preliminary overall area development plan

WOODLAKE
PARKWAY

INFORMATION SHEET FOR
PRELIMINARY OVERALL AREA DEVELOPMENT PLAN
(P.O.A.D.P.)

Re: Woodlake Parkway ☐ Preliminary Plan
☒ P.O.A.D.P.

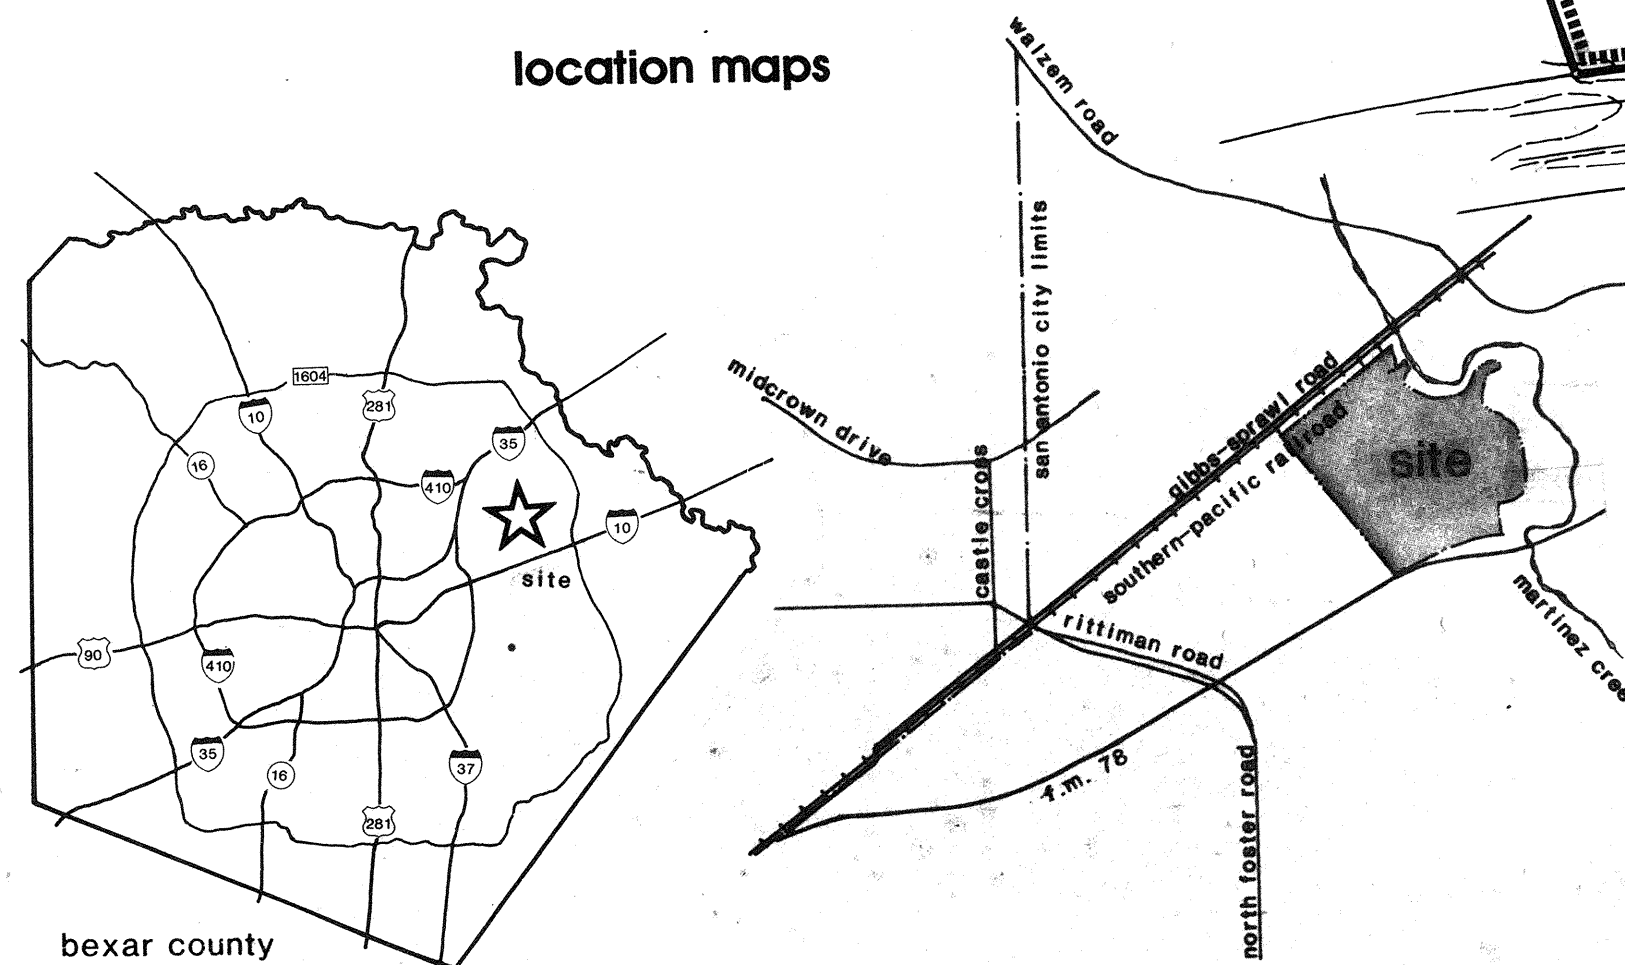
☒ Comments: Because of the development activity that is occurring in the immediate area, it will be necessary for you to coordinate the alignment of Woodlake Parkway with the Ray Ellison property to the north for proper alignment of said thoroughfare. Thank you.

WOODLAKE PARKWAY

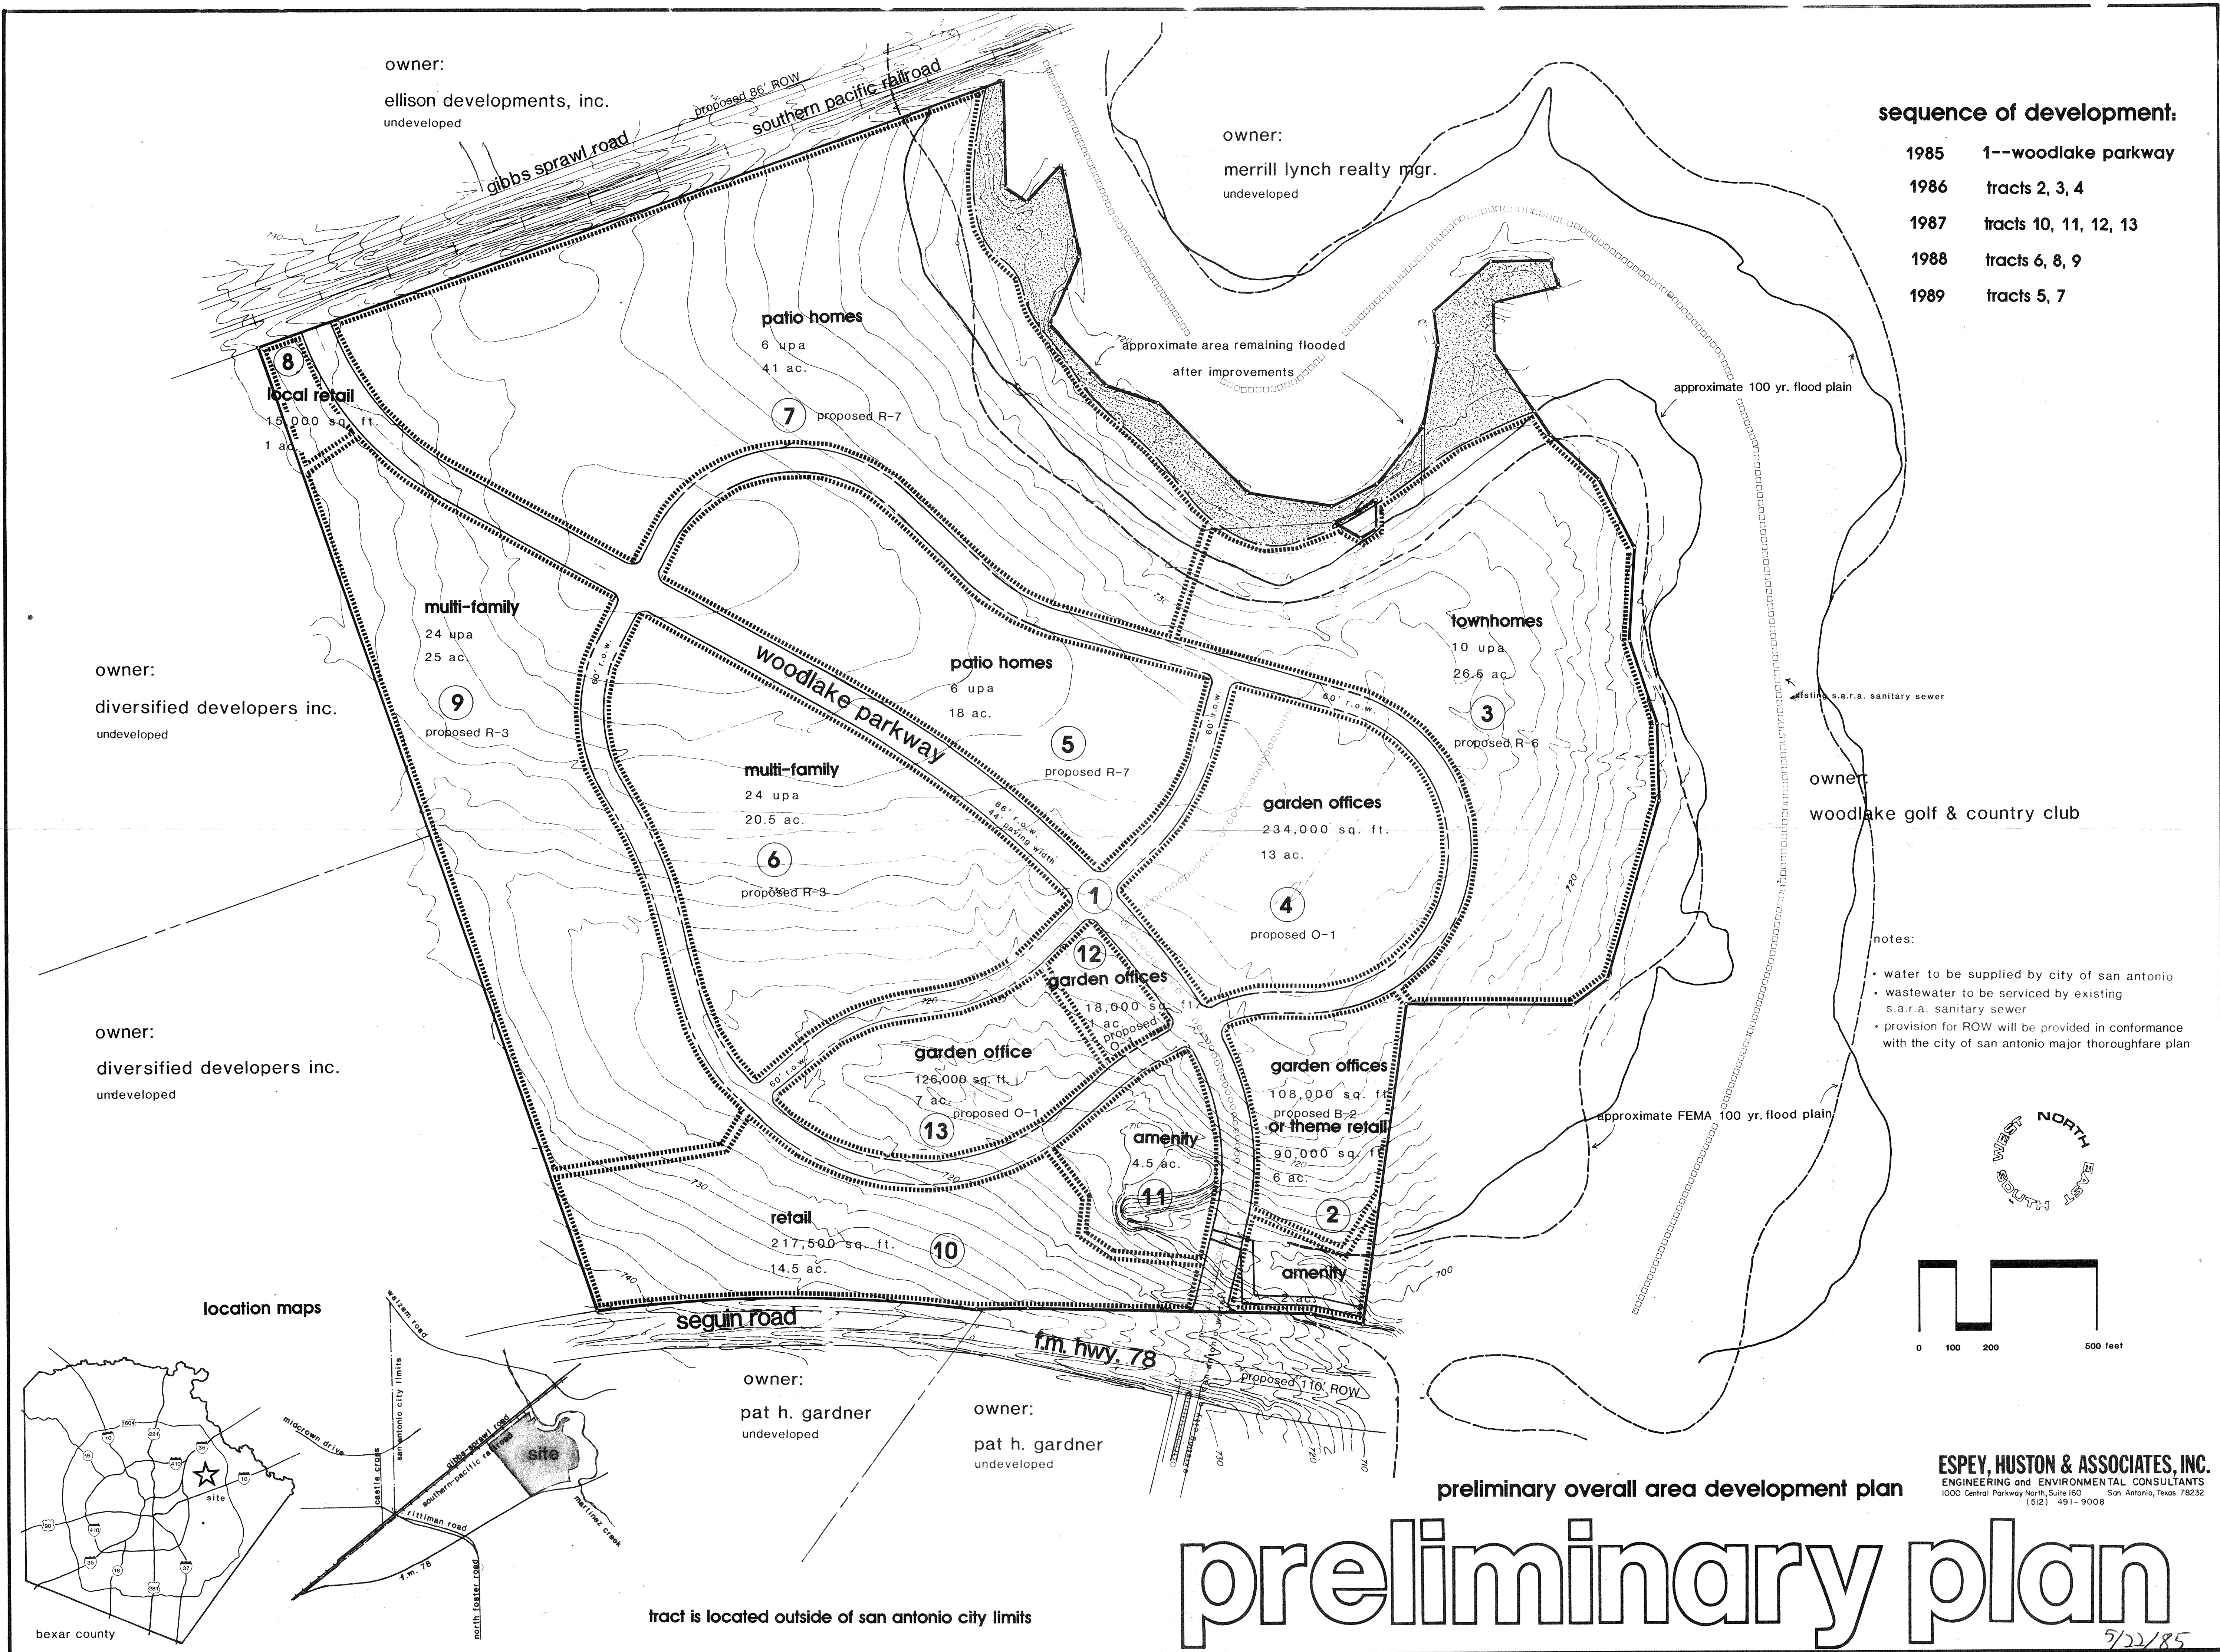
| () Street jogs or intersections | (X) <u>36-10(M)(1)(a)</u> |
| () Dead-end streets | <u>Type "B" local street</u> |

(X) Comments: The P.O.A.D.P. committee has reviewed your proposed plan for Woodlake Parkway and is recommending that the 50' R.O.W. be upgraded to a 60' local type "B" due to the abutting commercial development.

Remarks ROY, HERE ARE THE PLANS SHOWING THE
60' R.O.K. YOU REQUESTED. YOUR PROMPT
ATTENTION WOULD BE GREATLY APPRECIATED
